IN THE DRAWINGS

In accordance with the Response pursuant to 35 C.F.R. § 1.111 filed herewith, Applicants respectfully request approval to amended Sheets 3-6 of the drawings as follows:

Replace Sheets 3-6 of the drawings originally filed with the Application with the Replacement Sheets 3-6. Replacement Sheets 3-6 contain amended FIGURES 4 and 6A, 5, 6B and 6C, and 6D and 6E, respectively. It is submitted that no new matter is added by the amendments.

FIG. 1

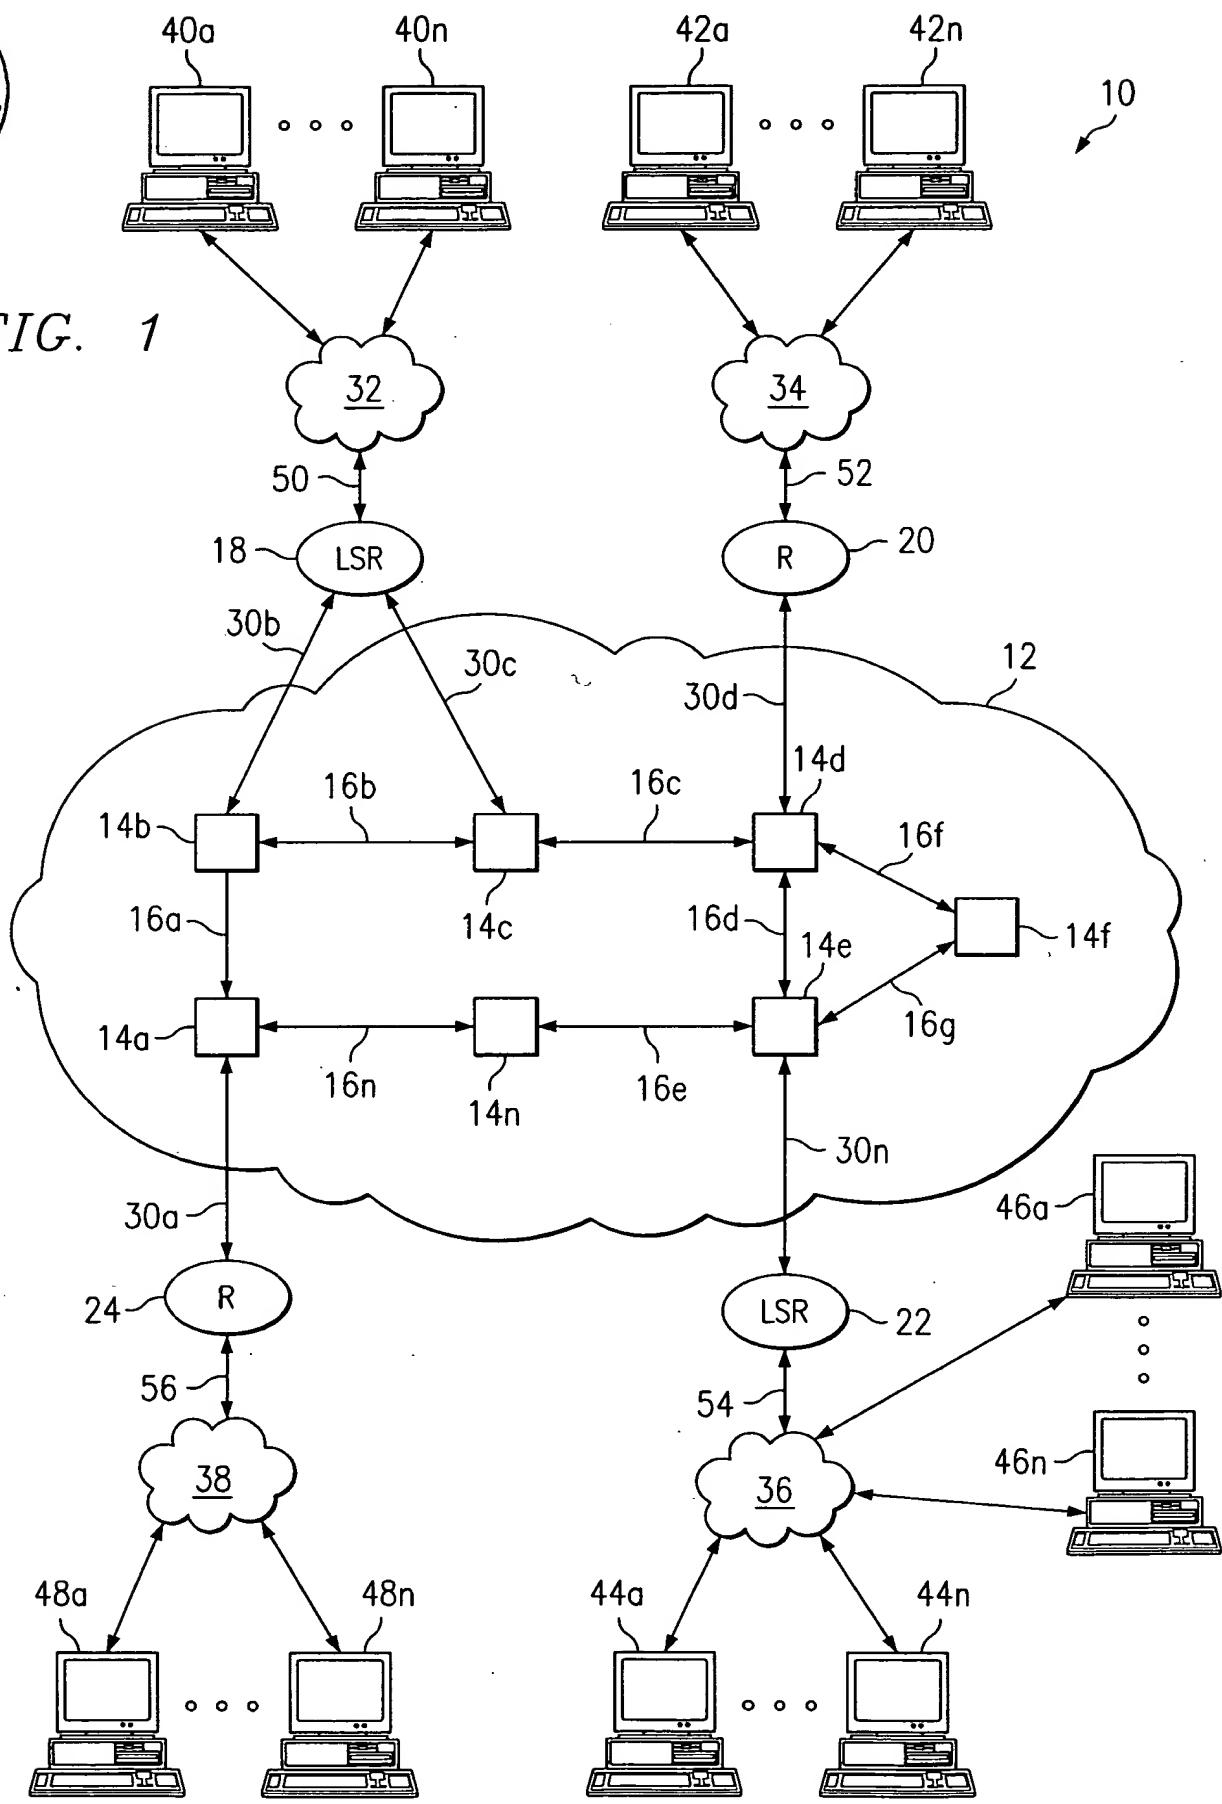
The drawings filed on June 6, 2000 stand objected to by the Examiner as failing to comply with 37 C.F.R. § 1.84(p)(5) because they include reference signs not mentioned in the description: 52, 56 (Figure 1); 310e-n, 310q, 312a-q (Figure 4); 226a, 228a (Figure 6A); 228b, and 228n (Figure 5B).

FIG. 6A

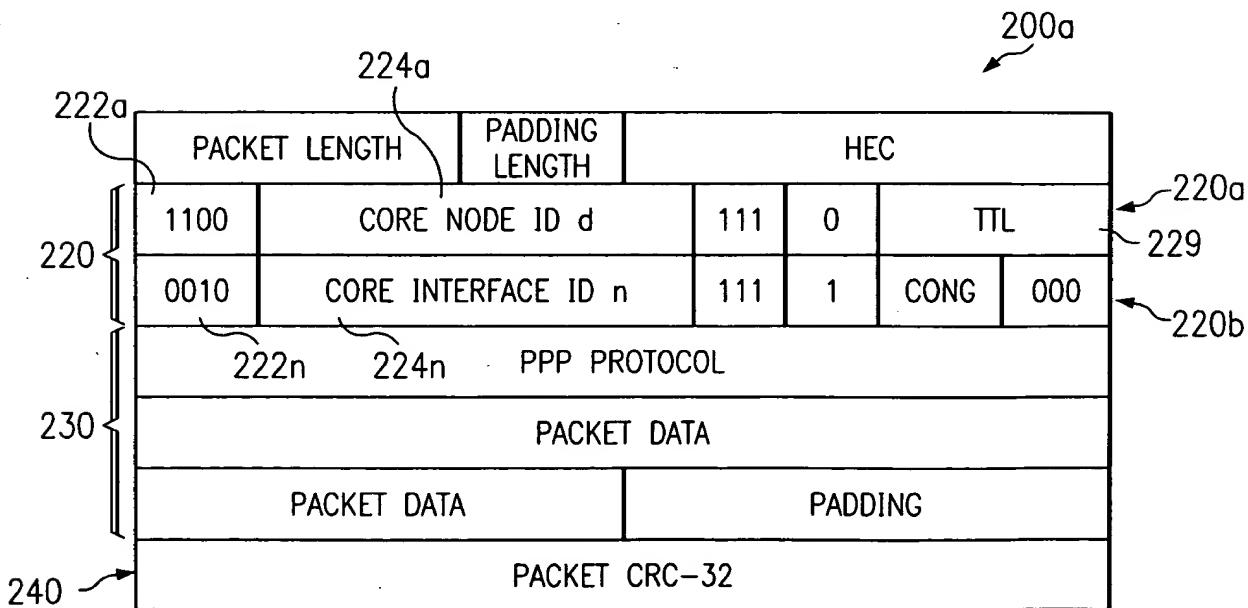
The drawings filed on June 6, 2000 stand objected to by the Examiner as failing to comply with 37 C.F.R. § 1.84(p)(5) because they do not include the following reference signs mentioned in the description: 220a and 220n (page 22, line 6, and all subsequent references to 220a and 220n regarding Figure 6A); and 222a and 222b (page 34, lines 11 and 19, and all subsequent references to 222a and 222b regarding Figures 6B-D).

Referring to Figure 6A, 200A should be corrected to 200a; and 229 should be corrected to 229a.

FIG. 5

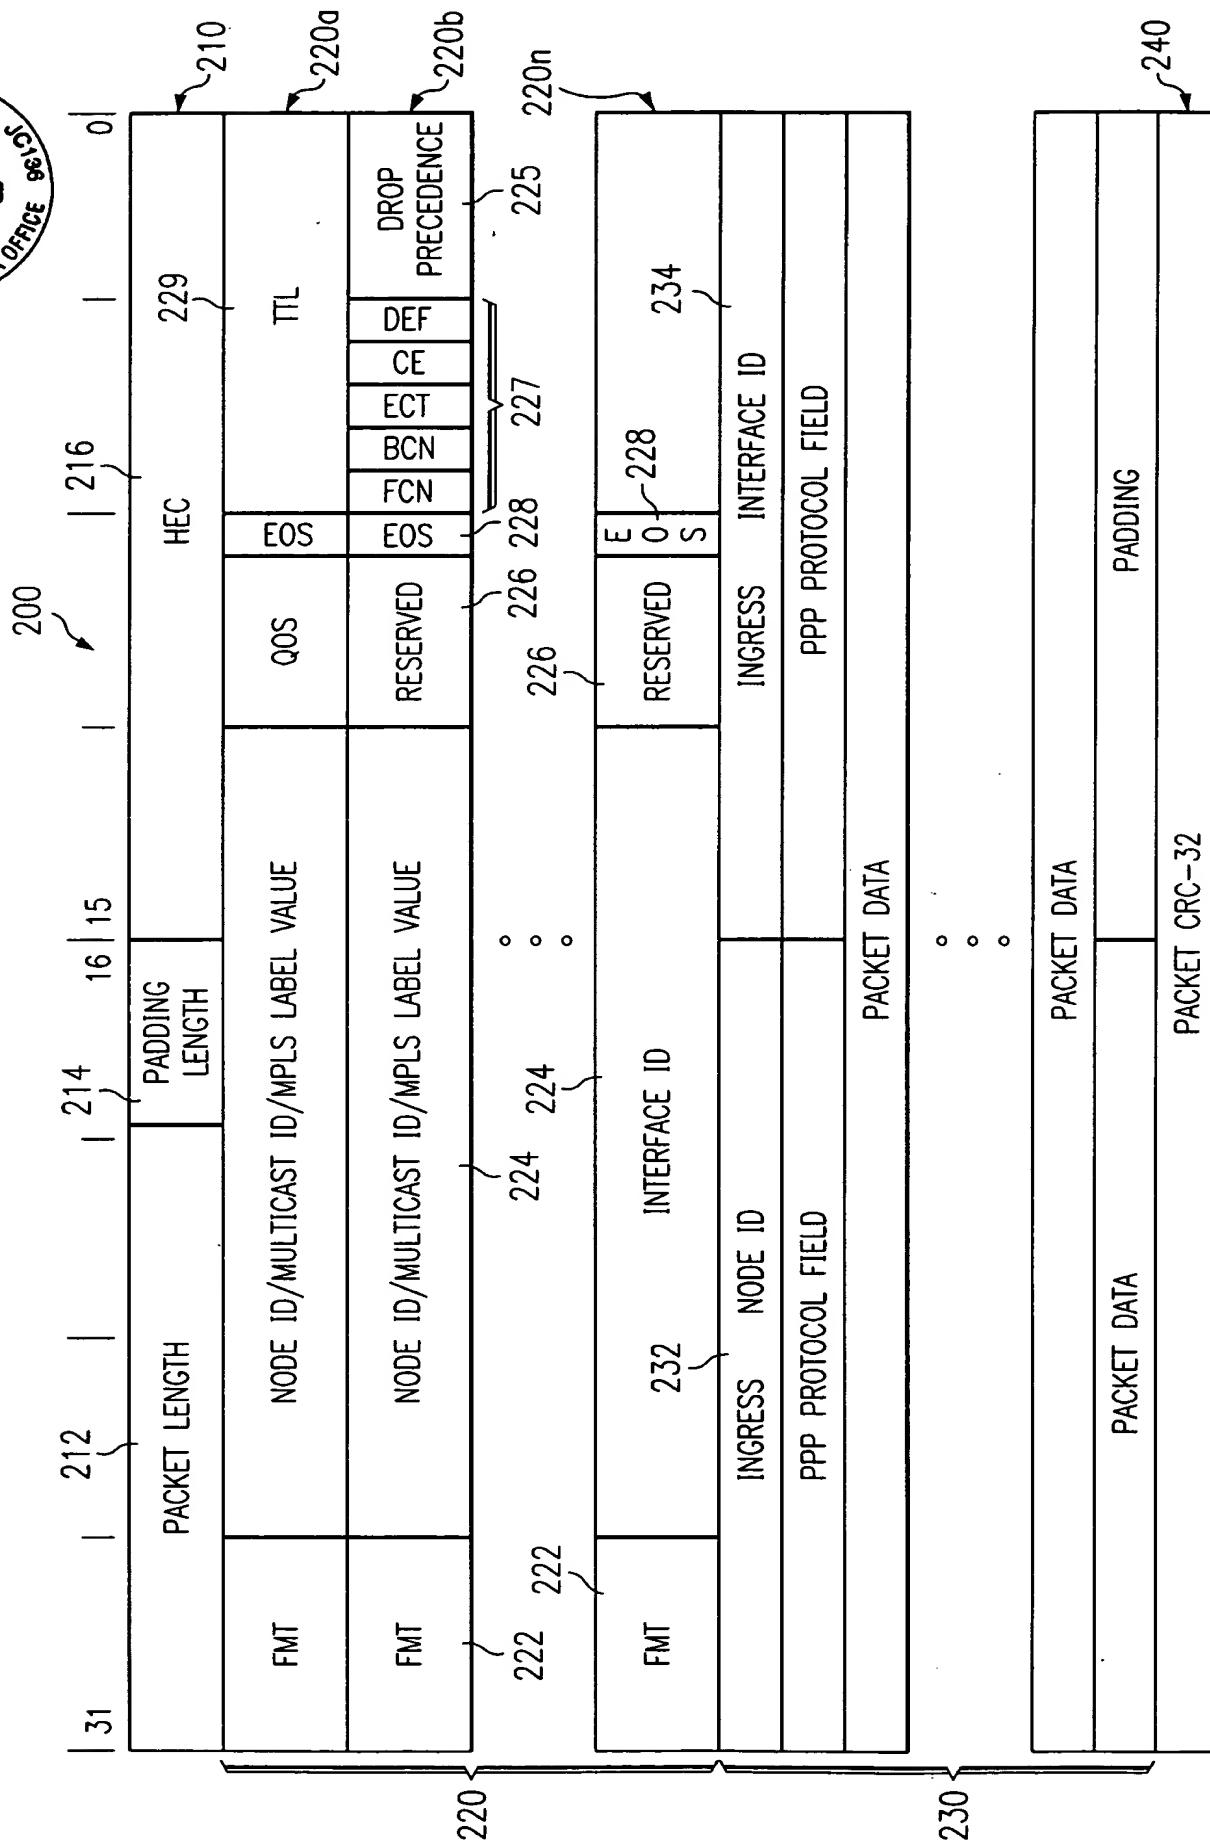
Referring to Figure 5, 210a should be corrected to 220a.

FIG. 6B

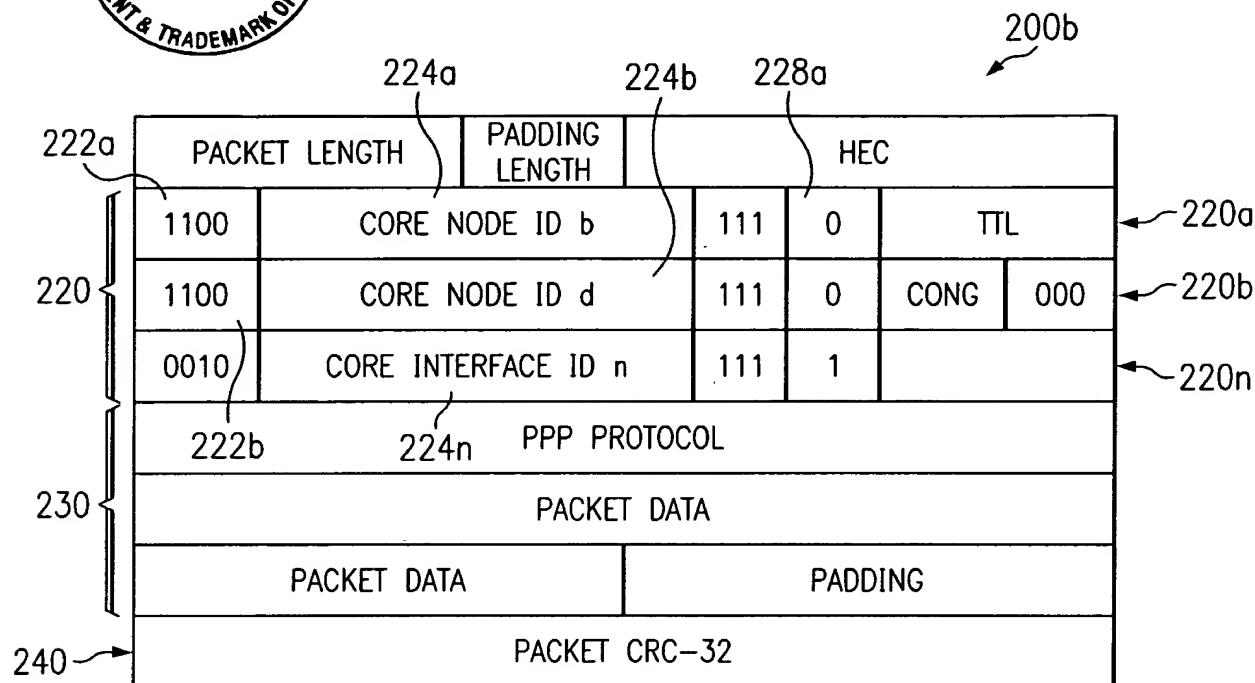
Referring to Figure 6B, 200B should be corrected to 200b.

FIG. 6C

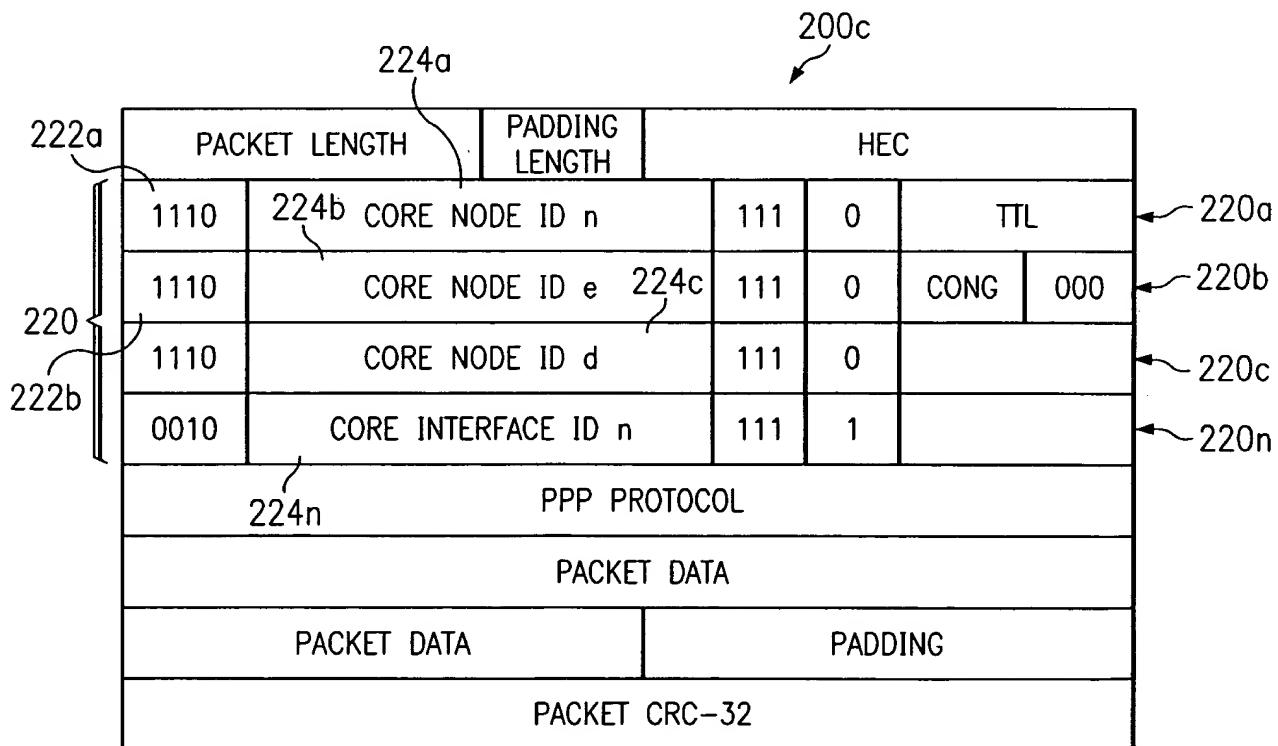
Referring to Figure 6C, 200C should be corrected to 200c.

FIG. 6D

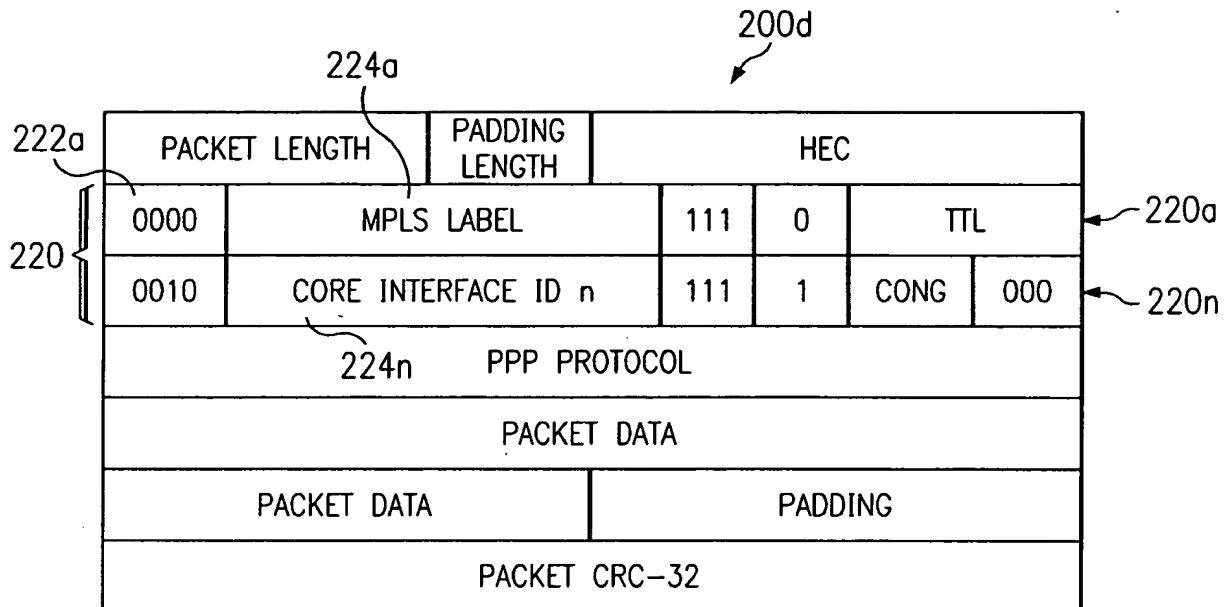
Referring to Figure 6D, 200D should be corrected to 200d.

FIG. 6E

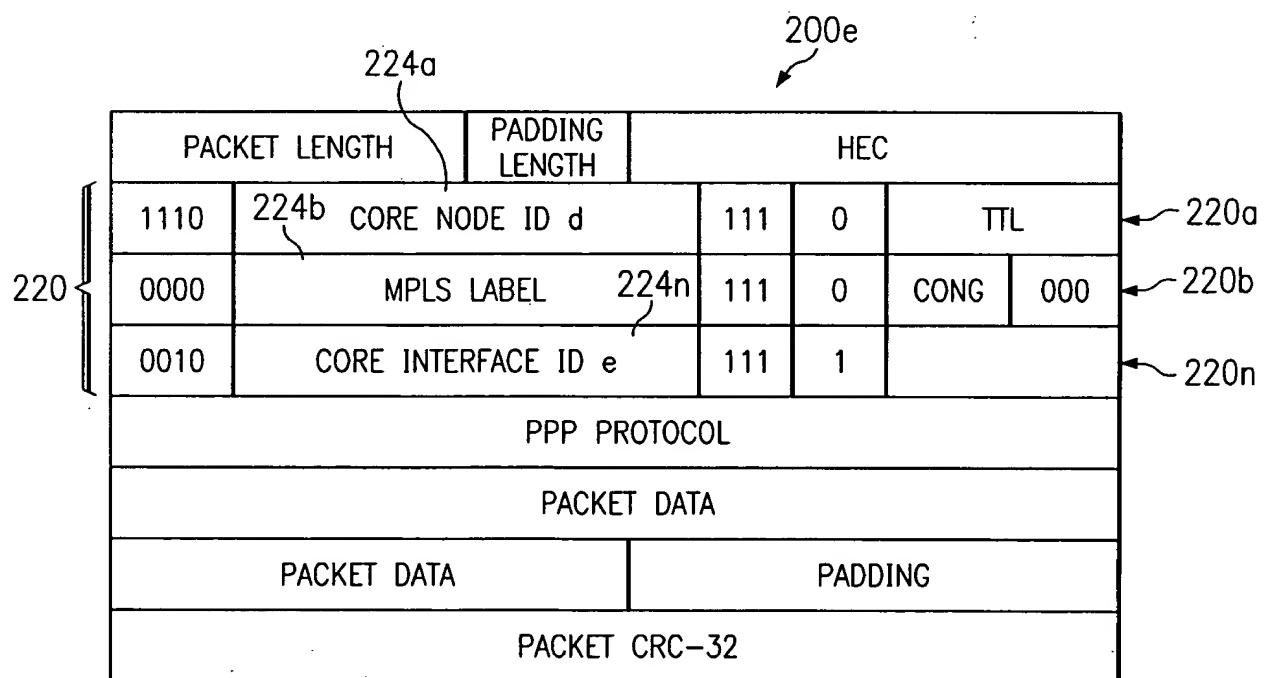
Referring to Figure 6E, 200E should be corrected to 200e.
